**CONTRACT CHANGE ORDER**

CCO No. 4	Suppl. No.	Contract No. 78713	Road 2017 Mt. Aukum Rd Sinkhole	Federal Number(s) ER-32LO(034)
--------------	------------	-----------------------	------------------------------------	-----------------------------------

**EL DORADO COUNTY  
DEPARTMENT OF TRANSPORTATION  
CONTRACT CHANGE ORDER**

**CCO NO. 4; REVISED TRENCH SECTION UNDERDRAIN (PAGE 3 OF 3)**

# TRENCH SECTION

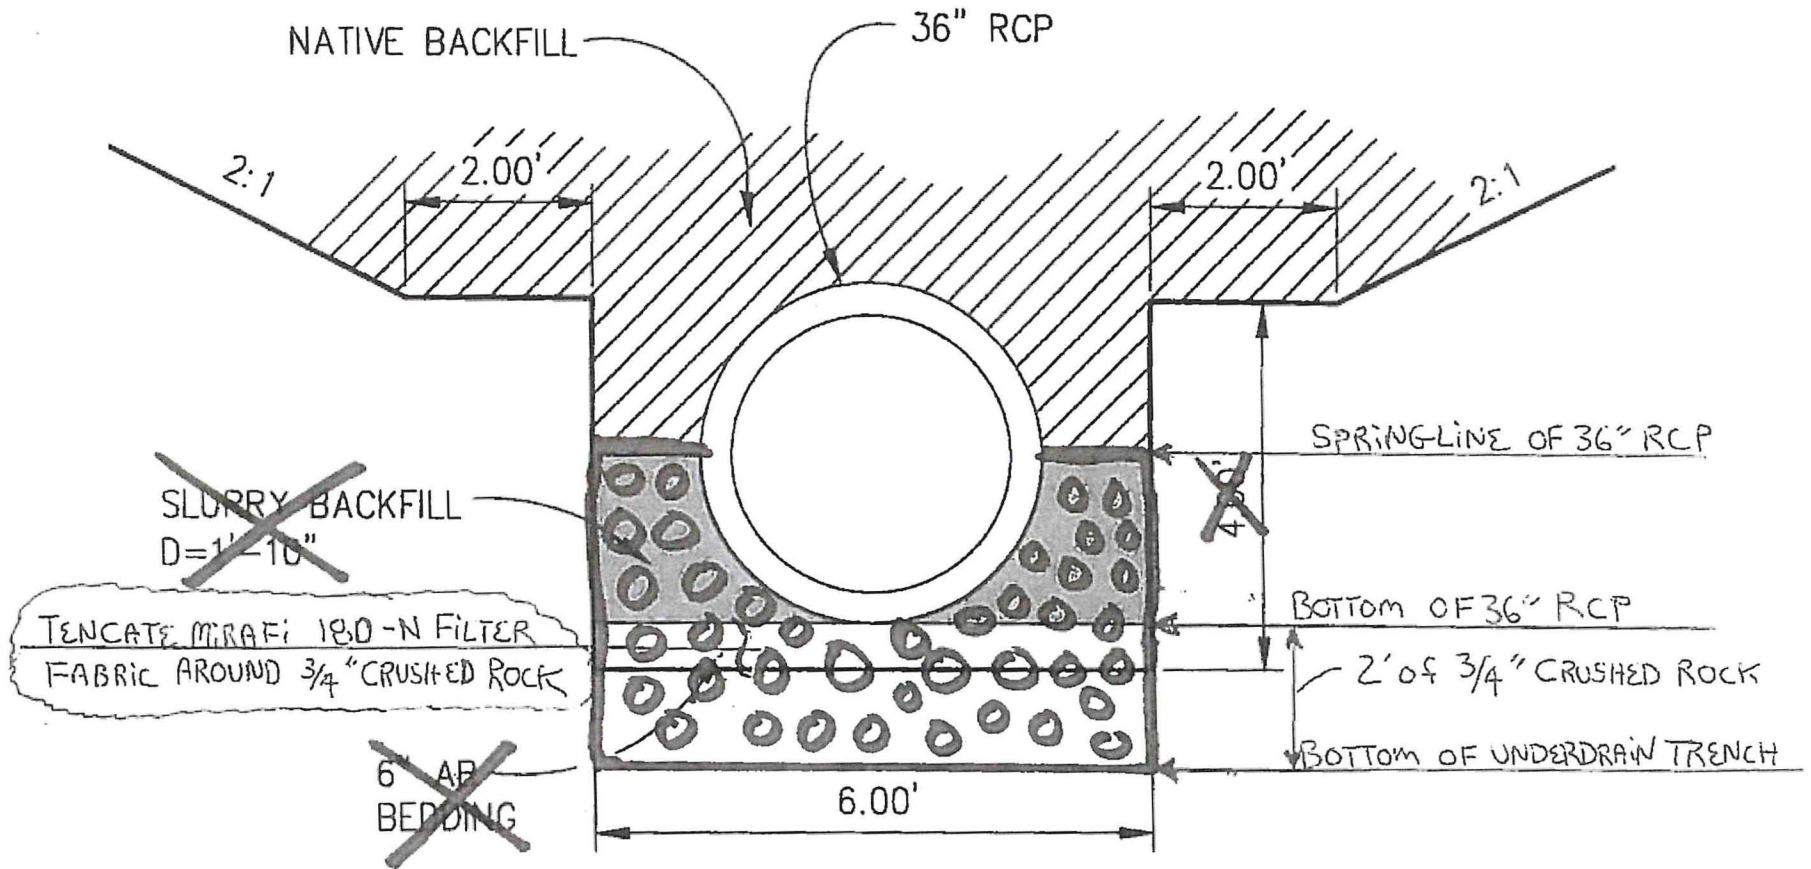
In accordance with Section 4-1.05, *Changes and Extra Work*, of the Standard Specifications, replace the "Trench Section" detail on contract Plan sheet "D-1, *Drainage System 'SD1'*" with the attached revised "Trench Section" detail.

As directed by the Engineer, provide all additional labor, equipment, and materials necessary to install 138-feet of the revised trench section underdrain from Headwall No. 1 to a point that is approximately 20-feet down pipe from Headwall No. 2. Install two separate 10-foot lengths of 6-inch perforated underdrain pipe thru Headwall No. 1 to transmit the groundwater into the adjacent rock lined ditch. For this work, the Contractor shall receive and accept \$45,369.00. This sum constitutes full and complete compensation for providing all labor, material, equipment, tools, and incidentals, including all markups by reason of this change.

In accordance with Section 4-1.05B, *Work -Character Changes*, of the Standard Specifications, eliminate the "6" AB BEDDING" shown on the "Trench Section" detail on Plan Sheet "D-1, *Drainage System 'SD1'*." In lieu of the AB bedding, place ¾-inch crushed rock as shown on the revised "Trench Section" detail shown on Sheet 3 of this contract change order. Payment for the crushed rock is included in the extra work at agreed lump sum price detailed above.
